Delegated Report

Planning Application No: 20260087

Location: 26 King Street Gravesend Kent DA12 2DU

Description: Installation of a traditional retractable external awning.

Proposed Front Elevation

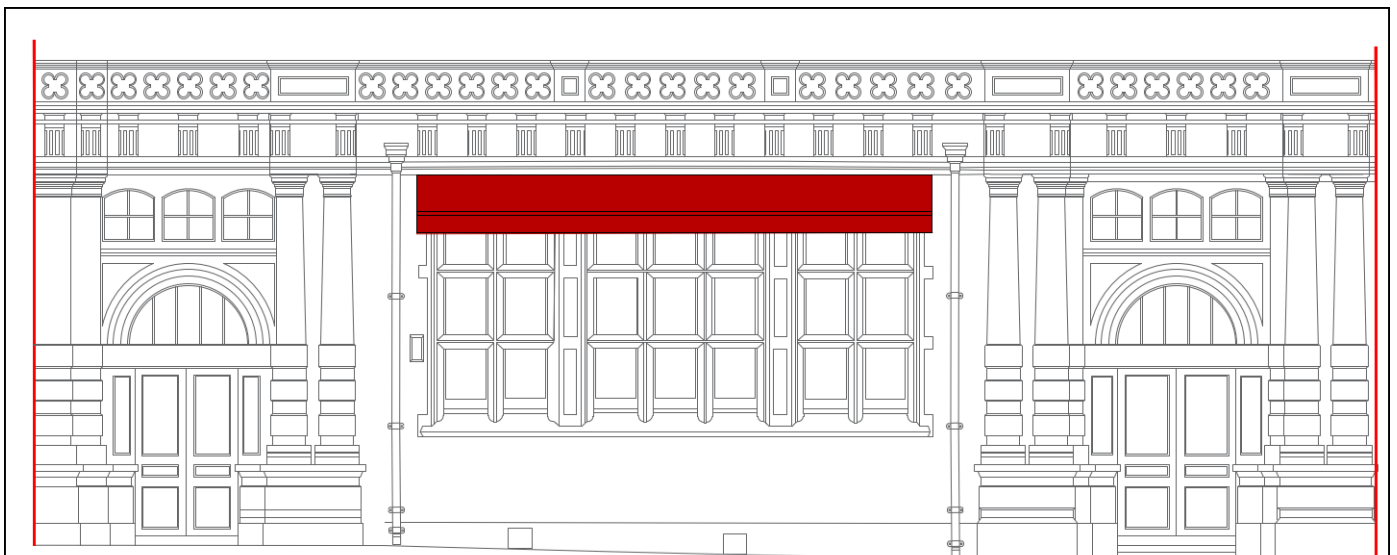
The proposed awning would be 7.1m wide and extend out to 2m deep.

In respect of the above, the awning would be retractable and made of a matt, woven fabric but it would not meet the other guidance for the following reasons. The proposed awning would extend across the upper portion of the traditional window openings, concealing the hood mould detailing which forms an important architectural feature of the building's façade. The red colour of the awning would appear visually prominent and would not represent a muted tone appropriate for a historic building. This would result in the awning having an unattractive and cluttered appearance. Awnings are a traditional feature of a shopfront but the one proposed here is not sympathetic for the reasons given and the property does not have a traditional 'shop front'. In addition, the details provided indicate that the mechanical fixing would be fixed into mortar joints where possible. However, the proposal is to install this above the window into the hood mould, there are no mortar joints in this area, of the string course above the window appears to be made from stone. Drilling fixings into the stonework could result in physical damage to the historic fabric, including cracking or spalling. As such, the drilling of fixings into the stone would impact the historic fabric itself, with potential for greater impacts on the historic fabric.

Under Section 16 (2) of the Planning (Listed Buildings and Conservation Areas) Act 1990, special regard must be had to the desirability of preserving a listed building or its setting or any features of special architectural or historic interest which it possesses. The proposal would introduce visually intrusive modern paraphernalia which would detract from the architectural composition of the historic façade and would therefore fail to preserve the special interest of the building.

Traditional retractable blind. The blind should not be used to increase advertising space.

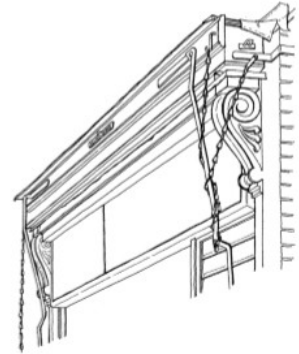
Many traditional shopfronts had retractable roller blinds to protect goods from sunlight and to provide shelter for pedestrians. In the past blinds were not used for advertisement purposes, whereas today, many modern type of blinds, such as the 'balloon' or 'Dutch' blinds, are essentially seen as a means to increase advertising. They are alien (and in many cases an obtrusive feature) in historic areas and are in general not acceptable on Listed Buildings and in Conservation Areas.

- Where traditional canvas blinds and blind boxes are still in place, these should be retained and restored.
- New blinds should be integrated within the design and construction of the shopfront. They should be positioned below the fascia so as not to obstruct the view of the shop name and, when retracted, should sit flush with the fascia.
- New blinds should be fixed in a way that they do not conceal any key architectural elements of the shopfront.
- New blinds should always be retractable when not required and ideally be of a traditional roller design. Fixed blinds or Dutch blinds are generally not acceptable.
- Blinds should be made of canvas or other non-reflective material. Shiny plastic materials used for fixed Dutch blinds are unlikely to find approval.
- The colour of the new blind should complement the colour scheme of the fascia and shopfront.

New blinds should be made of canvas and be fixed in a way that they do not conceal any key architectural features
